Access Compliance Report Public Rights-of-Way (Curb Ramps)

Main Street: HICKORY_BRANCH_RD		Cross Street: HICKORY_BRANCH_RD		Location:	SW
ADA ID: RPAT211008141727	Ramp Type: Type 4 - Parallel	Initial Pass/Fail: Pass	Overall Compliance: No	Severity Score:	0
Codes/Mitigation Info/Possible Solution			Field Measurements/Component Compliance

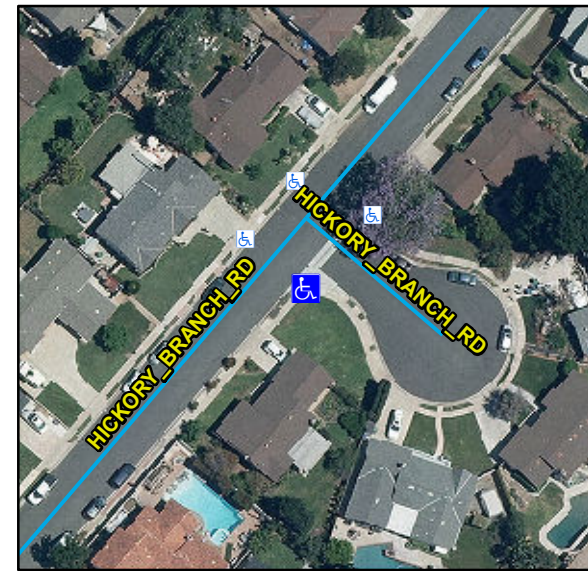
Compliance	Description	Data	Compliance	Description	Data
N/A	Ramp Length LT (in)	76	N/A	Ramp Length RT (in)	97
Yes	Ramp Width LT (in)	70	Yes	Ramp Width RT (in)	70
Yes	Ramp Run Slope LT (%)	6.6	Yes	Ramp Run Slope RT (%)	5
Yes	Ramp Cross Slope LT (%)	0.4	Yes	Ramp Cross Slope RT (%)	1
N/A	Landing Present	Yes	Yes	DWS Provided	Yes
N/A	Landing Length (in)	68	Yes	DWS Contrast	Yes
Yes	Landing Width (in)	48	Yes	DWS Length (in)	36
Yes	Landing Run Slope (%)	1.8	Yes	DWS Full Width	Yes
No	Landing Cross Slope (%)	2.2		DWS Offset Type	Single
N/A	Landing Movement Obstructed?	No	Yes	DWS Offset Left (in)	0
	Landing Movement Type	Curb	Yes	DWS Offset Right (in)	N/A
N/A	Landing Shared	No			
N/A	Clear Space	Yes			
N/A	Clear Space To Crosswalk (in)	48			
N/A	Marked Crosswalk 1	No	N/A	Marked Crosswalk 2	No
	Crossing 1 Direction	E		Crossing 2 Direction	N
N/A	Marked Crosswalk 1 Width (in)	N/A		Marked Crosswalk 2 Width (in)	N/A
N/A	Ramp Inside Crosswalk 1	N/A	N/A	Ramp Inside Crosswalk 2	N/A

Remove & Replace Landing.
